August 5, 2009

Austin Generation Resource Planning Task Force  
Austin City Hall  
301 West 2<sup>nd</sup> St.  
Room 1029  
Austin, Texas 78701

Re: A Critique of some of the assumptions used in the Austin Energy Resource Plan

Exhibit 45: Forecast of World Oil Supply

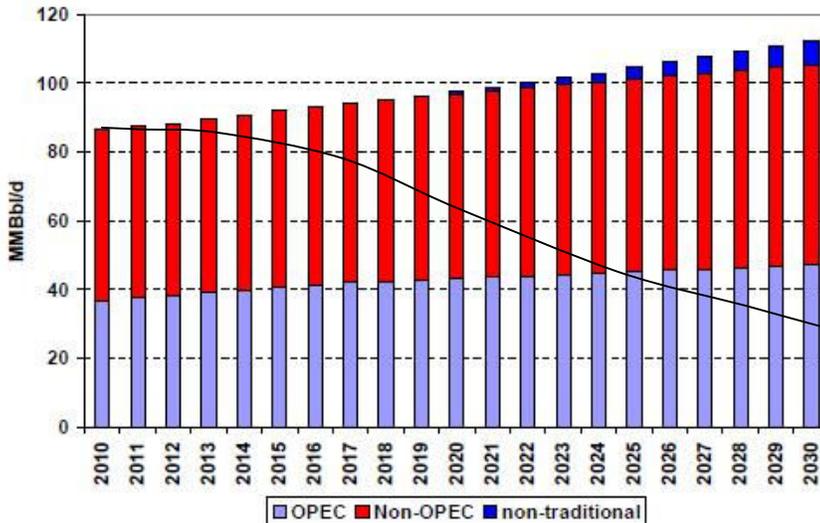
- 5) **The world oil supply in Exhibit 45 is too optimistic.** World oil production is currently peaking. Old wells are decreasing in their production. New oil is deep and far out into the oceans requiring ever increasing costs to obtain the new oil. The increasing oil price will cause oil demand to decrease with time so that the dwindling oil supplies match the amount of oil consumers are able to pay for.
- 6) **Coal power risks are understated in this study.** The coal industry is in a period of great risk. Sequestration is unproven. Its costs are unknown. Do you think the two Fayette units Austin owns 50% interest in can pump 3 million lbs of CO<sub>2</sub> per hour into the ground without CO<sub>2</sub> leakage or well water contamination?

<http://www.lifeaftertheoilcrash.net/> (this forecast is laid on top of the above graph)

Charles Gibson talks about the sources and cost of oil. The important point is that the new oil requires going ever deeper and deeper into the ocean, thus raising the costs:
